**DESIGN REVIEW BOARD MEETING  
PACKAGE**

*June 15, 2021 (Tuesday), 12:00pm  
Council Chambers, 2<sup>nd</sup> Floor, City Hall  
199 Queen Street  
Live Streaming: [www.charlottetown.ca/video](http://www.charlottetown.ca/video)*

**Design Review Board Agenda** (June 15, 2021) ..... (p.3)

# LOT 18-2 SHERWOOD ROAD MASTER PLAN

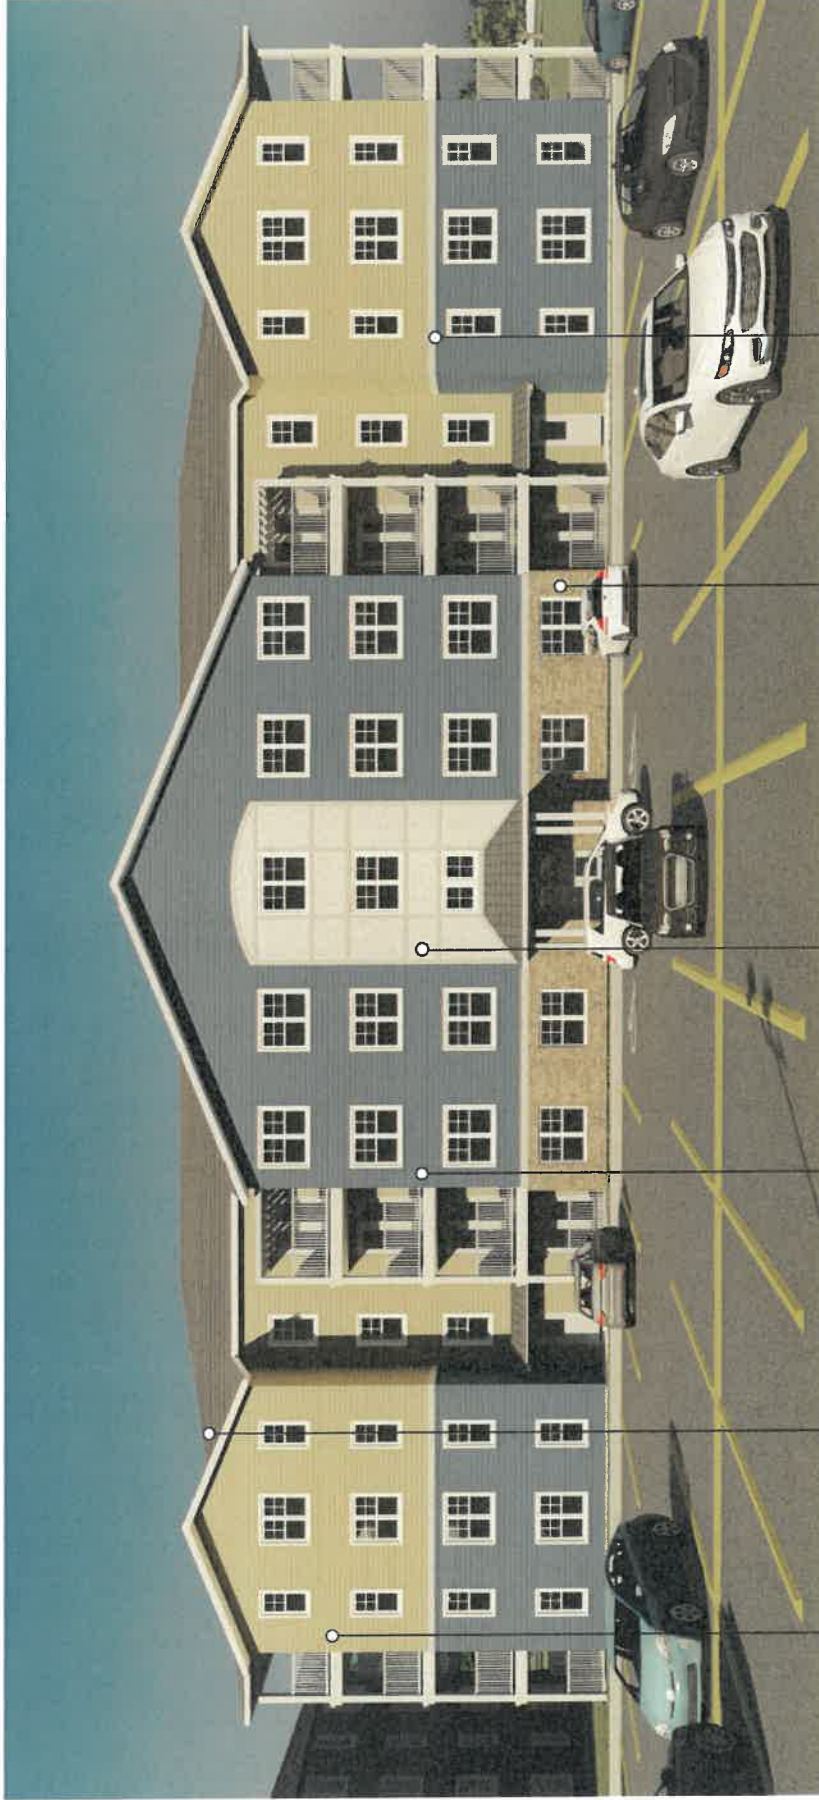
Although there are not too many examples of good architecture on Sherwood, this design is not improving the character of the area. A lot more in terms of design could be done to improve the character of the two buildings and create a sense of pride for both the owners and the tenants without a significant change in the choice of material costs.

There isn't a landscape plan as part of the submission. It would be beneficial to develop a plan that will be complimentary and functional in the amenity space, as well as providing foundation to the base of the building and providing shade both in front of the building, the other sides of the building, and in the amenity space. Connecting the sidewalk to the street or to the edge of the property at the site entrance is always good as some people do walk and or jog off site. This creates a safe access to the buildings out of the drive aisle.

1. Developing a detailed site plan with emphases on soft and hard landscaping features around the base of the building and ;
2. Extending the sidewalk from the buildings to the street or entrance of the property;
3. Reviewing a way of changing the look/massing of the buildings from a long horizontal appearance to a vertical one;
4. Revisit the apartment building(s) main entrance to better define the entrance and provide more shading; and
5. Distinguish the two (2) apartment buildings apart with different materiality and colour.
